Re: Application ID: 6-3038-00081/00003; Tom Sunderlin/White Lake Granite Quarry

Thank you for comments outlined in your NOIA letter dated April 26, 2021. Please find the following summarized response in this letter Addendum and revised Mine & Reclamation Plans for the White Lake Granite Quarry project site.

Re: Project Permit: 2021-0075; Tom Sunderlin/White Lake Granite Quarry

Thank you for comments outlined in your NIPA letter dated April 20, 2021. Please find the following summarized response in this letter Addendum and revised Mine & Reclamation Plans for the White Lake Granite Quarry project site.

MINE PLAN MAP

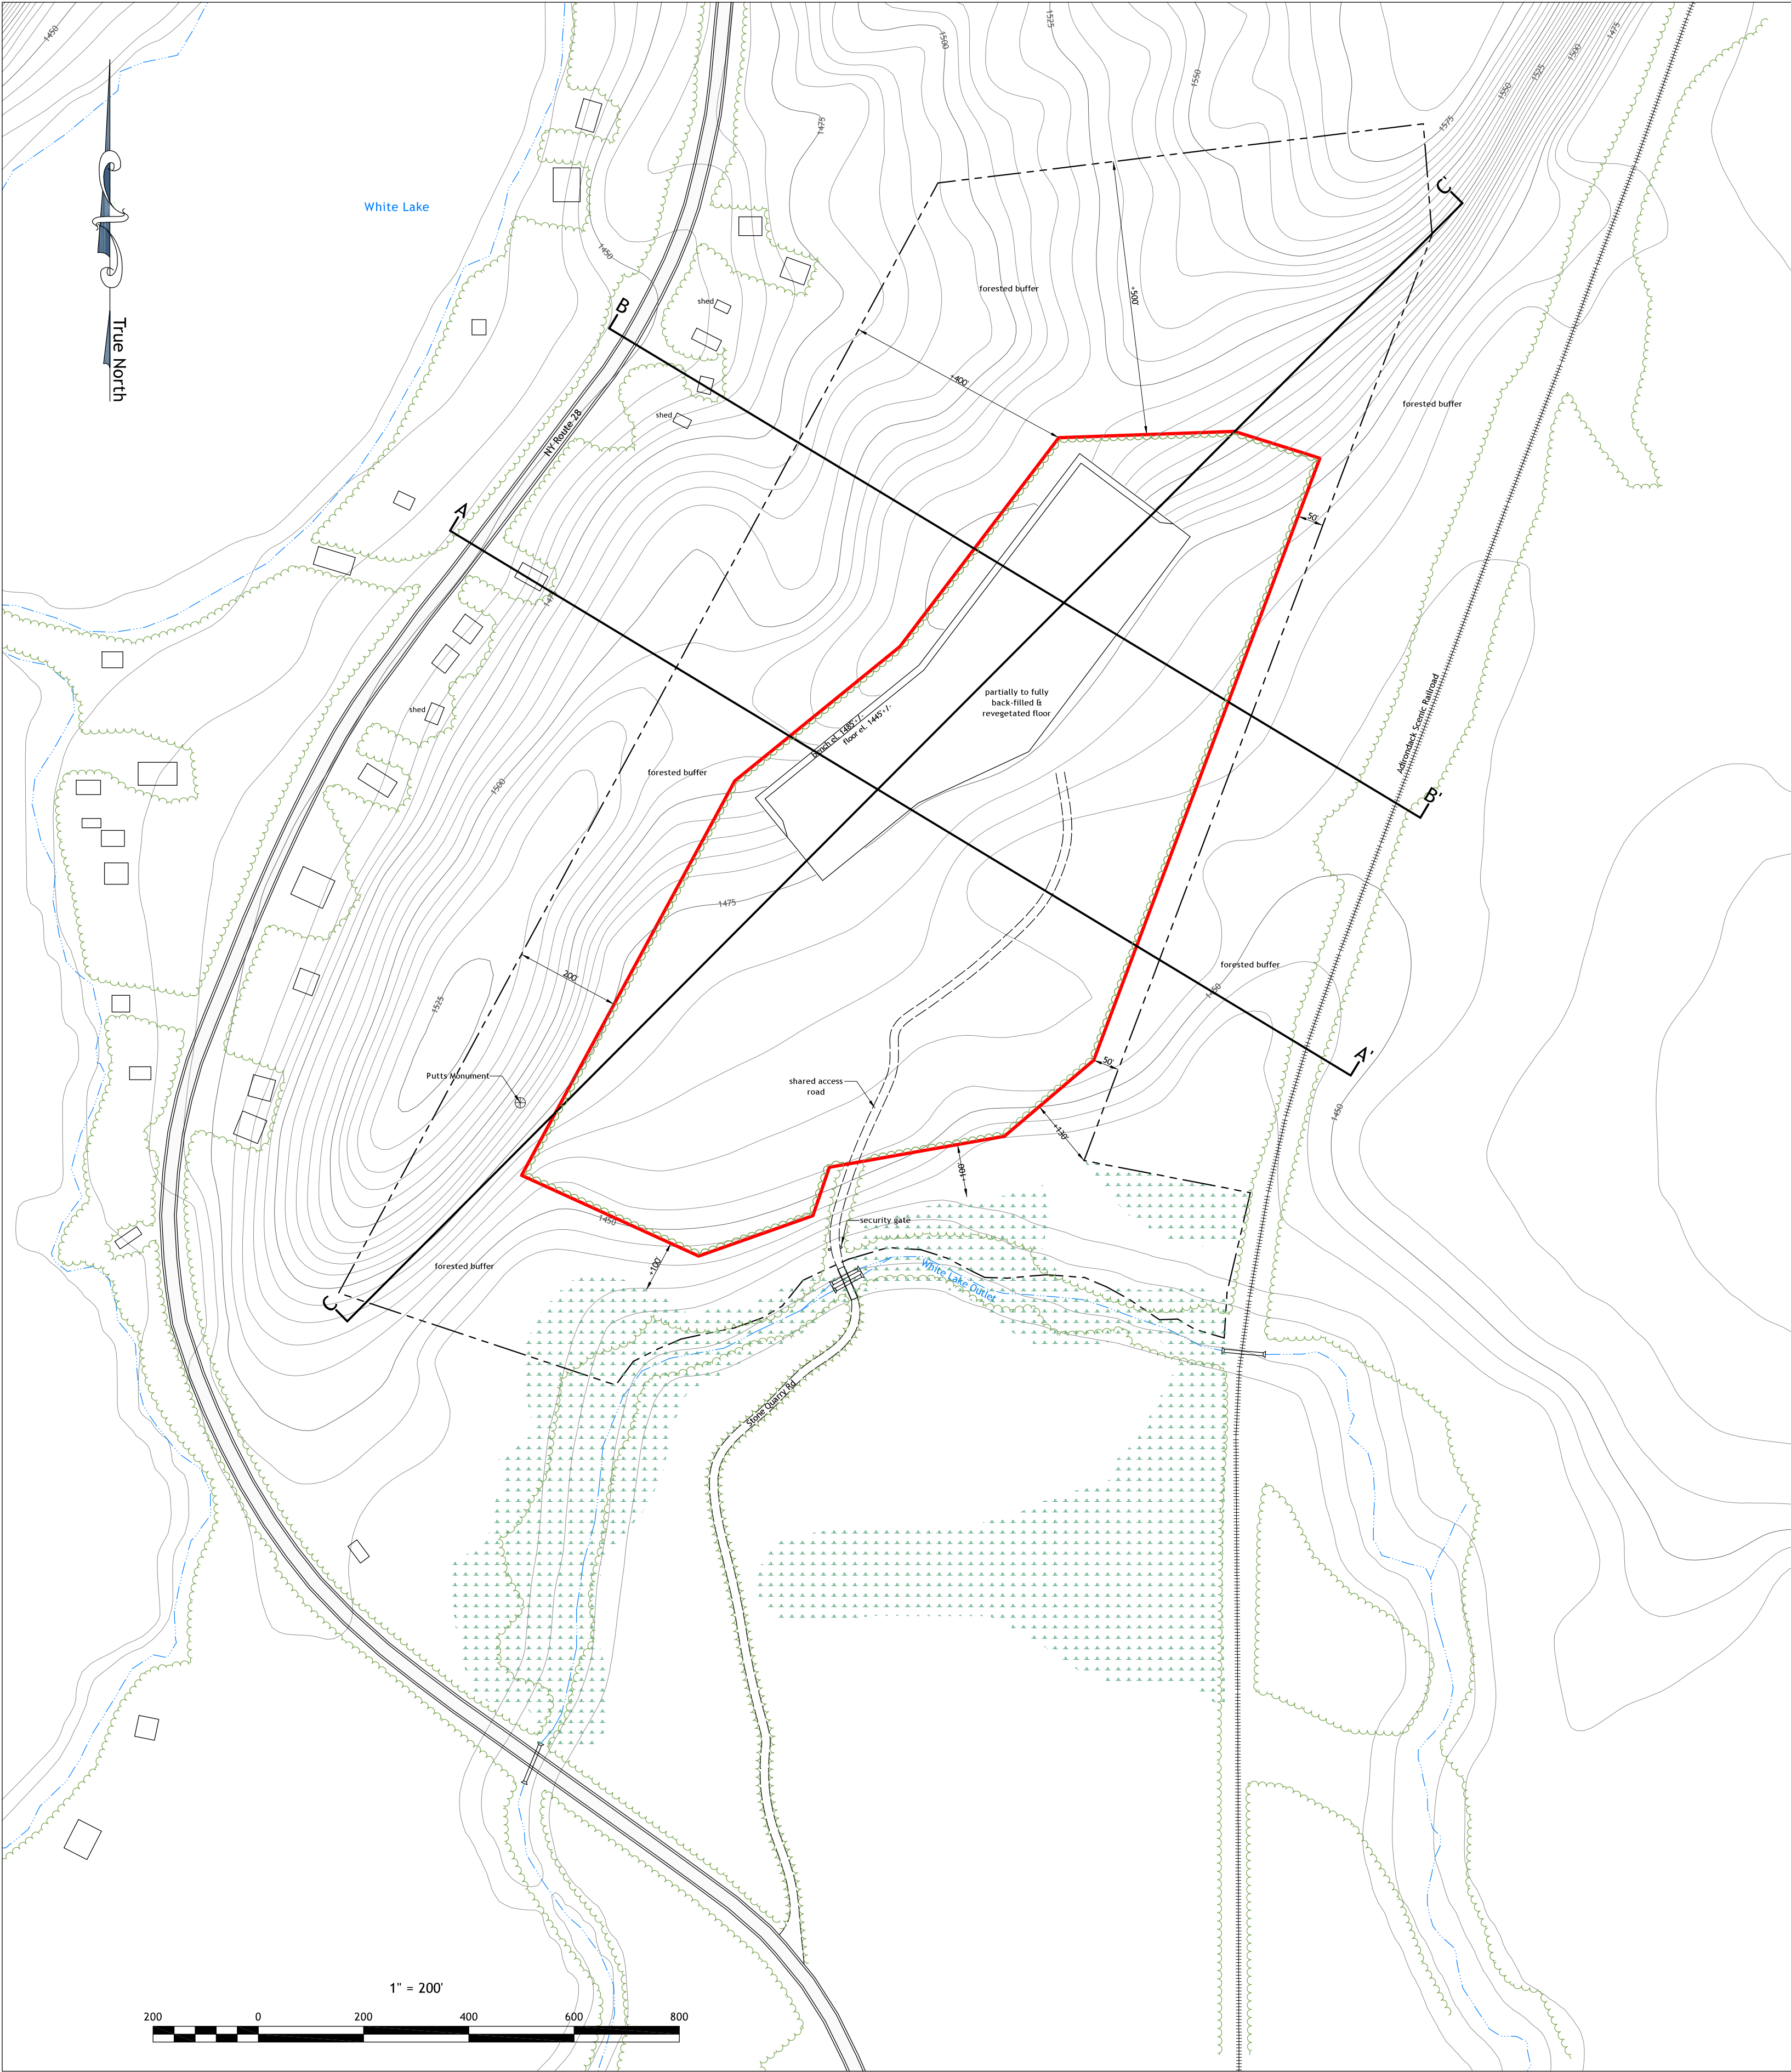
1. *Describe and illustrate in the narrative and Mining Plan Map all erosion and sediment control structures that will be installed to retain all storm water on site, if any.*

3. *Describe and illustrate in the narrative and Mining Plan Map a general location of the portable processing plant and stockpiles.*

6. *SIR Item 7 - Mine Plan Map: Please revise this map to also include the following:*

- *Proposed limits of vegetative clearing and a label for the existing limits of vegetative clearing;*
- *Revise the affected area and its corresponding calculation to also include the entire excavation area; and*
- *Wetland revisions described in Item 1 above.*

improvements or for external sales based on market demand, if any. The plant will be placed within the mining support area in the general location of the “portable processing plant area” note added to the revised Mine Plan Map. Based on necessity of safe and efficient operations the plant will need to be placed on relatively flat ground roughly at the lowest elevation practicable.

The limits of existing vegetative clearing are indicated on the revised Mine Plan Map with a "Treeline/Hedge" line and note. The maximum potential limits of clearing to the LOMB are shown on the revised Reclamation Plan Map. In reality, clearing will not reach the LOMB but rather will be constrained to the minimum space necessary to conduct safe and efficient operations. The operator is further incentivized to limit the area to be affected under the financial burden of the reclamation bond, which increases as more area is affected.

The proposed affected area for the initial five-year permit term has been revised to include 8.8+/-acres. Only the portion of the proposed excavation area shown in orange hatch is intended to be affected over the initial permit term. The area is depicted as such to aid NYSDEC in establishing an appropriate value to be held in the bond.

RECLAMATION PLAN MAP

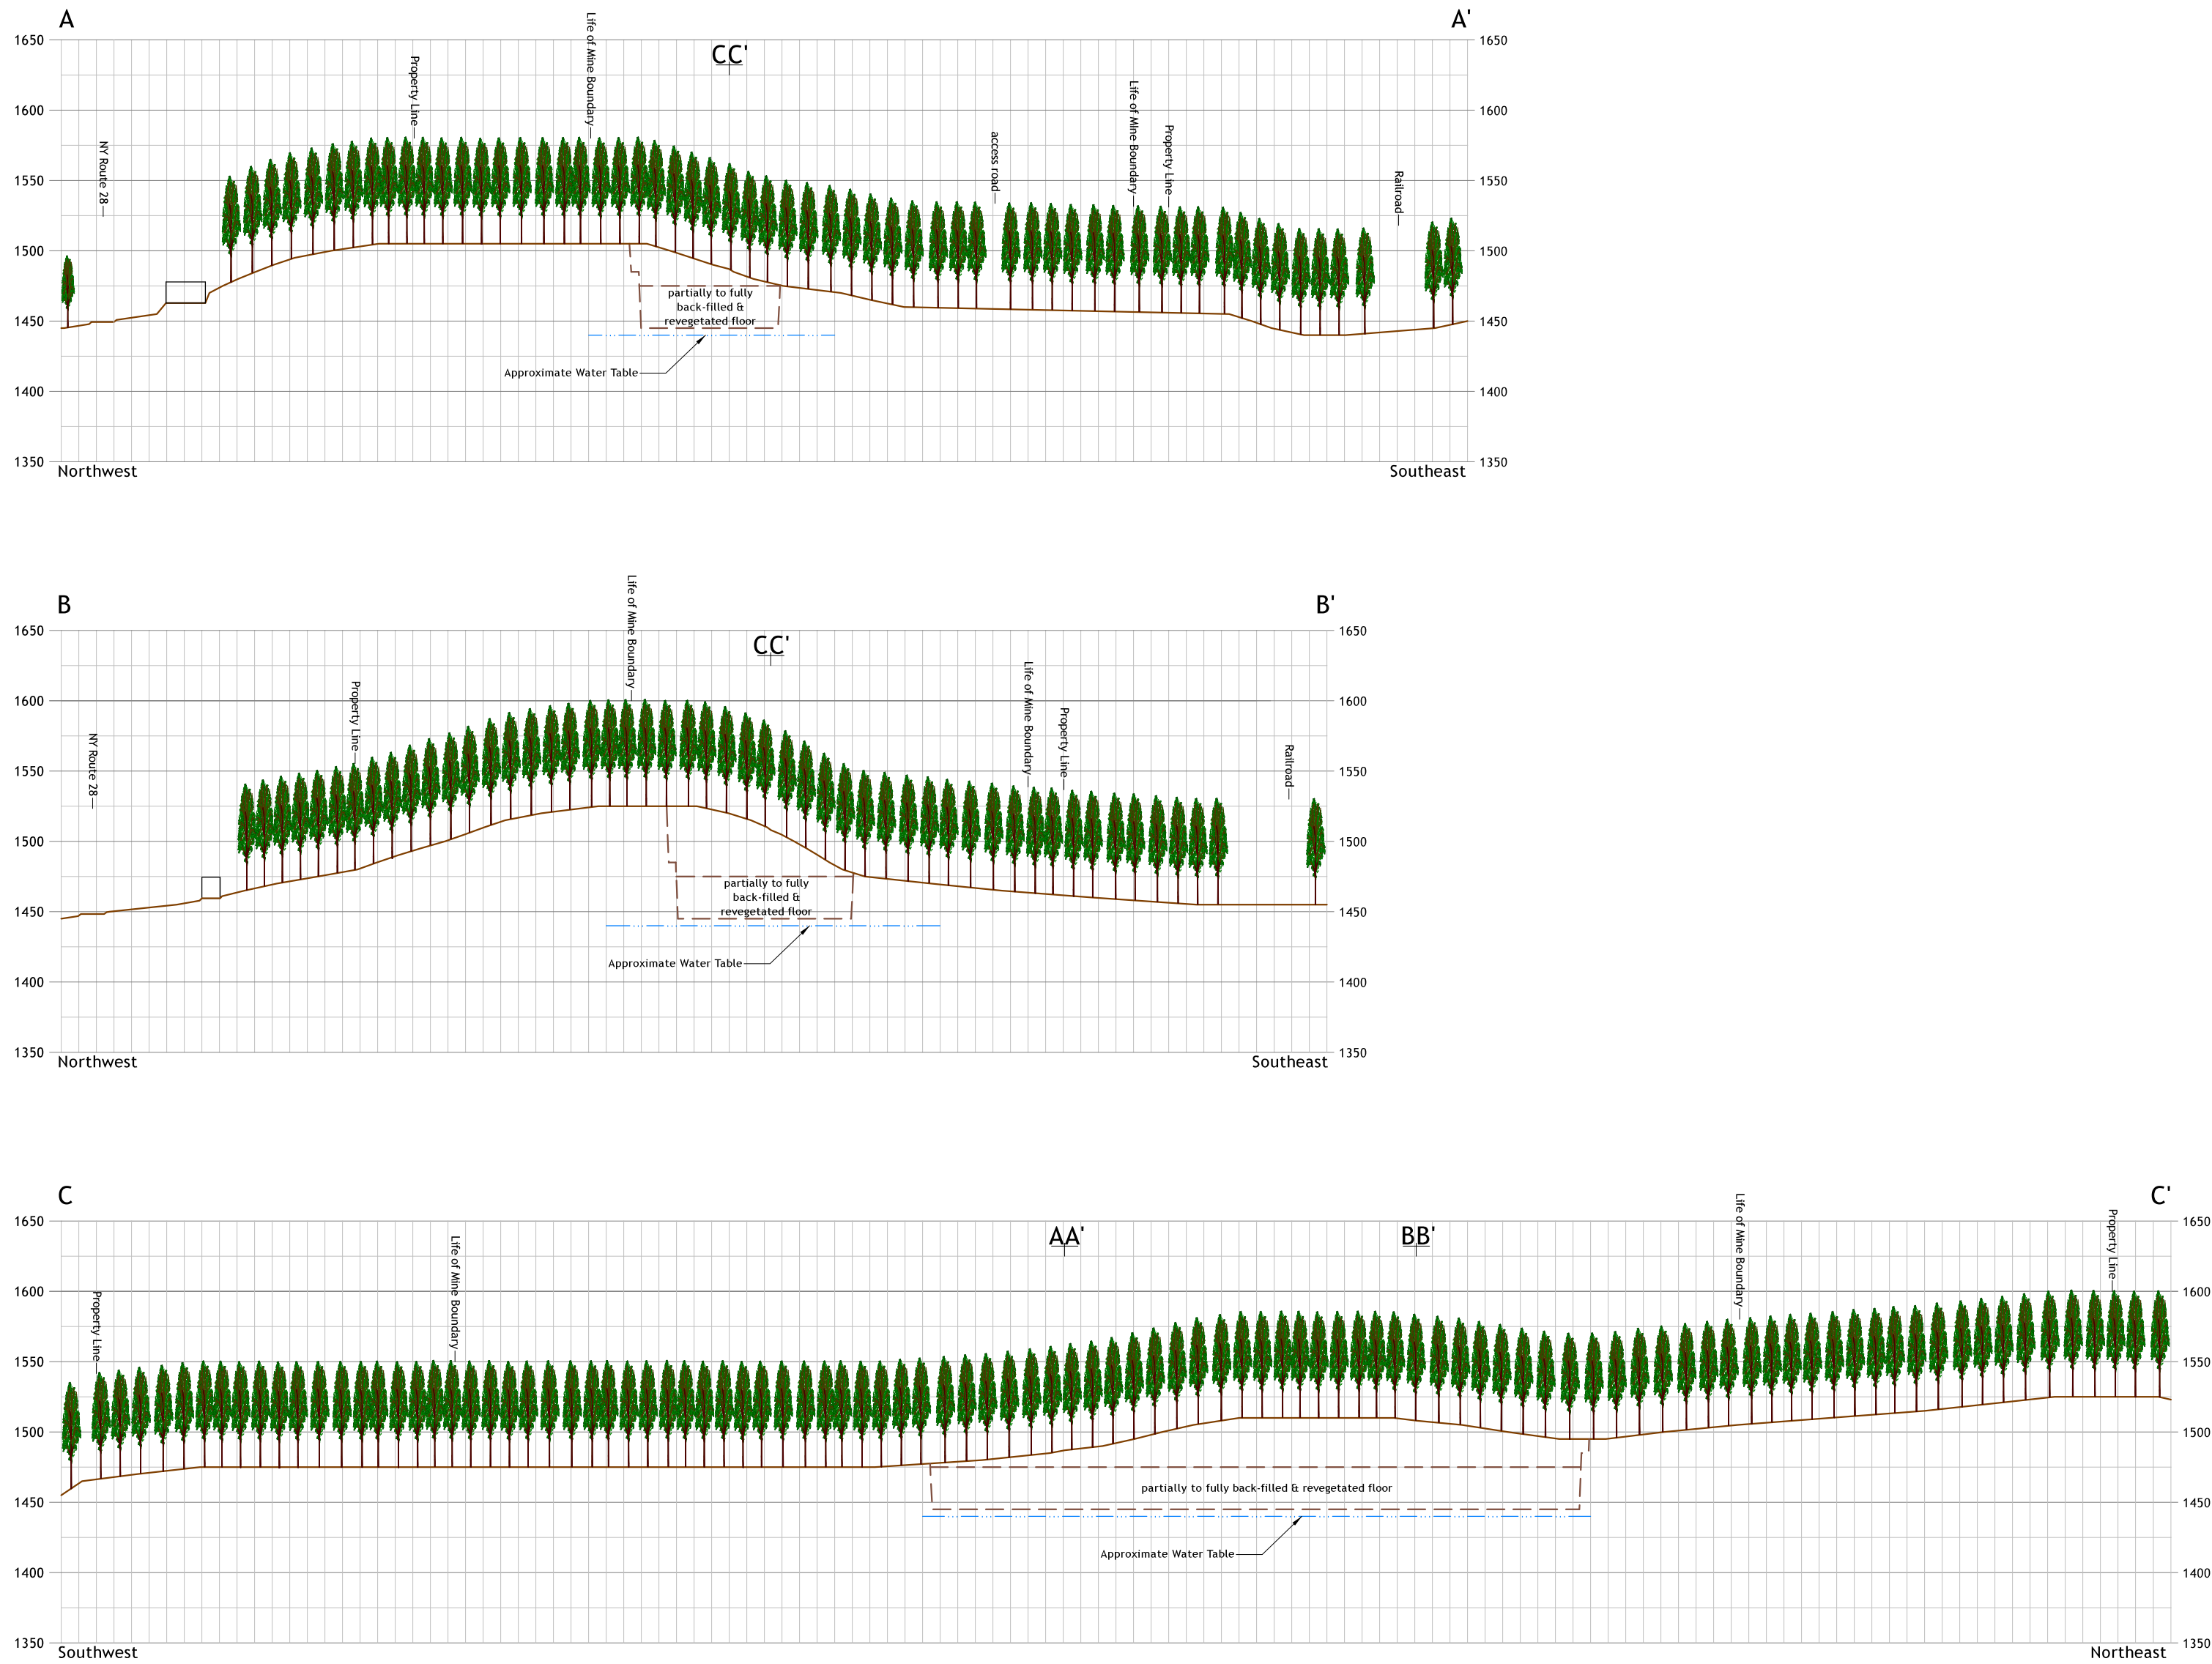
5. *Describe the final grade of all slopes, besides the vertical bedrock face, during the reclamation process.*

1. *General Information Request Item 13- Wetlands: Please revise the maps titled "Mine Plan Map and Reclamation Plan Map, prepared by SMS to also include the portion of wetlands described as being located on the southeastern property corner and depicted on the enclosed wetlands air photo interpretation, to show a 100-foot buffer from wetlands in this area to the proposed LOMB. Field verification of wetlands may be required if the proposal changes to include development or mining activities near the 100-foot wetland buffer.*

Proposed final grade is generally shown on the revised Reclamation Plan Map included with this submittal. Final grade of all slopes not shown as vertical or sub-vertical shall be no steeper than 1.5 to 1. For instance, the quarry floor will be backfilled using native residual rocky waste fragments to a slope 1.5 to 1 or less and subsequently covered with soil overburden for revegetation. The mining support area will be finish graded to approximate original contour, covered with soil overburden and seeded for revegetation. Please also refer to Section 5.0 of the MLUP for a detailed description of proposed final reclamation.

The proposed LOMB is revised as requested to avoid wetlands and the 100-foot buffer. The adjustment results in a 0.1+/-acre reduction in the proposed LOMA to 26.6+/-acres. Land disturbance of any kind is not proposed to occur in wetlands or the 100-foot buffer.
